PREVOST

**SAFETY
RECALL**

SR15-29

DATE :	JULY 2015	SECTION :	10 - Front axle
SUBJECT:	Dana Independent Front Suspension

Figure 2

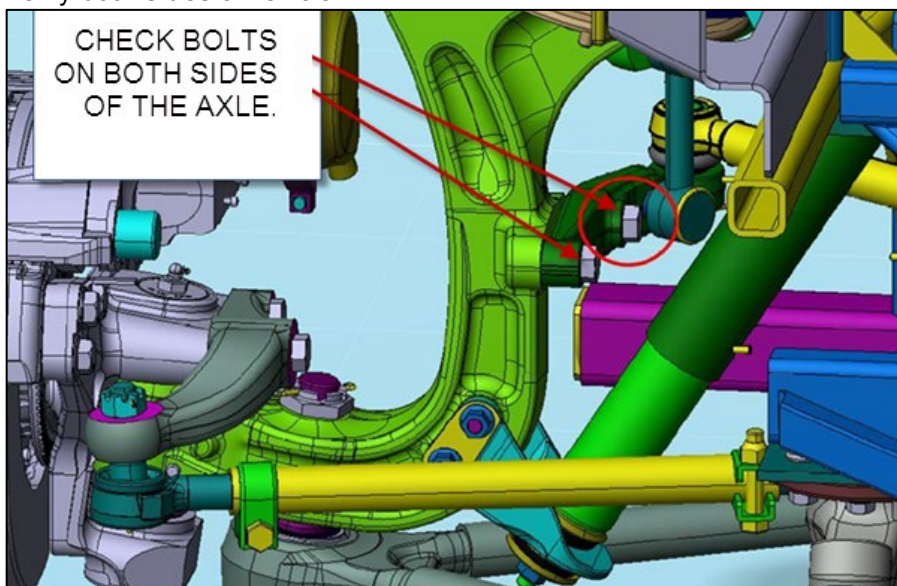
On the front independent suspension, inspect the bolts highlighted in fig. 2. Note that you may have to remove the shocks and the sway bar links to perform the replacement. Support the body on both sides before removing any components.

- 1) Verify the bolt head for the marking "OF". If present on one of the bolts, replace BOTH bolts

- 2) Verify **both sides** of vehicle

- 3) Replace one bolt at a time
 - Short Bolt M20 X 60 G12.9 PN 611305 QTY 2/VEH
 - Long Bolt M20 X 80 G12.9 PN 611307 QTY 2/VEH
- 4) Run a **M20 X 2.5 size tap** in the threaded section of the axle. You have to go from the back side and not the bracket side
- 5) Clean the bolt thread as well as the support thread using degreaser. Dry with compressed air.
- 6) Apply 271 Loctite or Permatex 27100 on bolt and threaded hole
- 7) Torque to **547 FT LBS**, Qty: 2 per side
- 8) Apply undercoating on Bolt heads
- 9) Reinstall sway bar links. Torque to **165 lbf-ft**.
- 10) Reinstall shocks. Torque to **110 lbf-ft**.
- 11) If no **"OF"** marking on the bolts, the vehicle is Conform.
